Town of Parker Community Development Department
 Development Review Division
 Attention: **Stacey Nerger**

Application Type: **Site Plan – Non-Residential**
 Status: **First Referral**
 Application Name: Trails at Crowfoot F9 AMD 1 Gas and Convenience Store
 Case/AP#: **SP22-119**
 Referral Received: October 27, 2022
 Comments Due: November 29, 2022

Application Location: Southeast corner of Bayou Gulch Road and N. Pinery Pkwy
 Review date: **November 10, 2022**
 Plan reviewer: **Randall L. Capra, rcapra@parkeronline.org**
 Phone: 303.805.3163

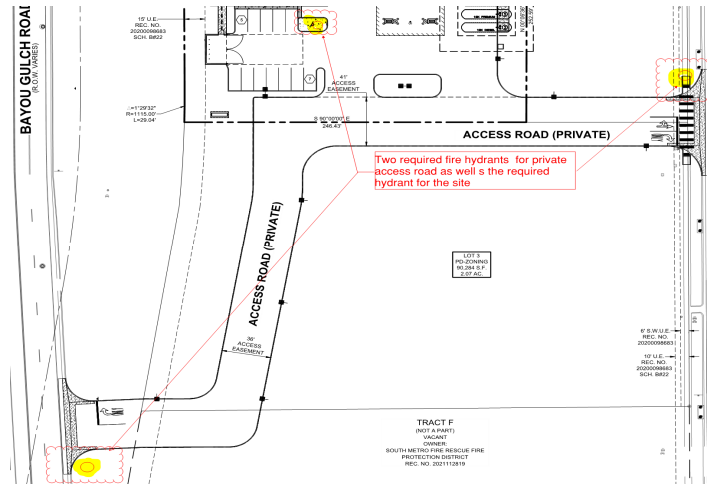
6. **Utility Plan Set:** The applicant shall provide a utility plan that identifies the locations of all utilities on the site (including natural gas and electricity). The overall utility plan shall identify the location of the required fire hydrant(s) and the required underground fire line UFL). The plan set shall identify the UFL on the plan (not just providing a note) while providing the length and diameter of the UFL (as measured from the T at the water main to the flange within the building. Address this issue on the plan set when resubmitting. ***In addition to the on-site hydrant required above, two additional fire hydrants will be required; a fire hydrant shall be located at the intersection of the private road access and Bayou Gulch Road as well as at the intersection of the private access road and Alpine Phlox Street.*** Address this issue on the plan set when resubmitting (see below for location of the two required hydrants for the private access road.

RESPONSE: UTILITY PLAN SET HAS BEEN PROVIDED WITH SUBMITTAL. ADDITIONAL FIRE HYDRANT PROVIDED AT BAYOU GULCH ACCESS. EXISTIN HYDRANT NEAR ALPINE PHLOX TO BE UTILITIZED. ADDITIONAL HYDRANTS TO BE PROVIDED IN FUTURE AT TIME OF DEVELOPMENT IF NEEDED.

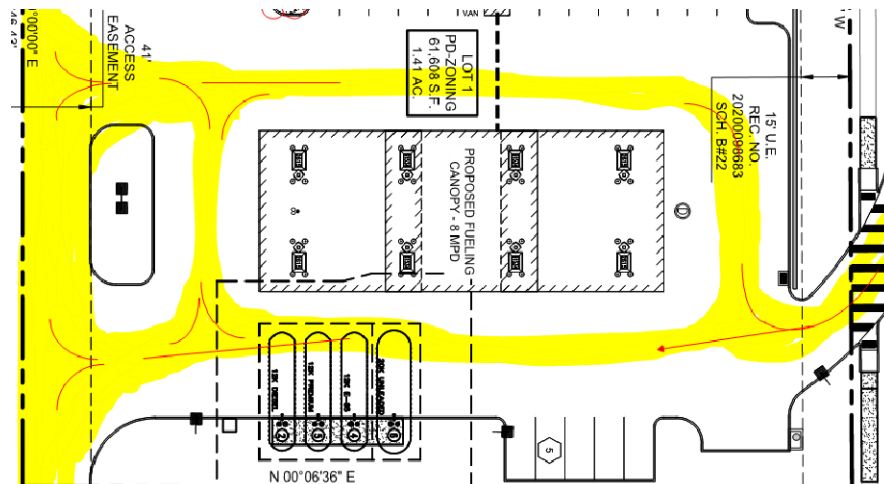
9. The applicant shall provide an auto turn analysis indicating that apparatus can navigate all portions of this site (both sides of the gas canopy); NO PARKING – FIRE LANE signage is required for any portion of the access where the 20-foot clear width requirement cannot be met. This is applicable for the loop around the canopy as well as for each entry. The access on each side of the canopy shall meet his requirement with no portion of the canopy encroaching into the required fire lane access road. See below for the areas required to be included in the auto turn analysis and address when resubmitting (failure to address all locations will result in a delay in approval for this project):

RESPONSE: PROVIDED PER COMMENT
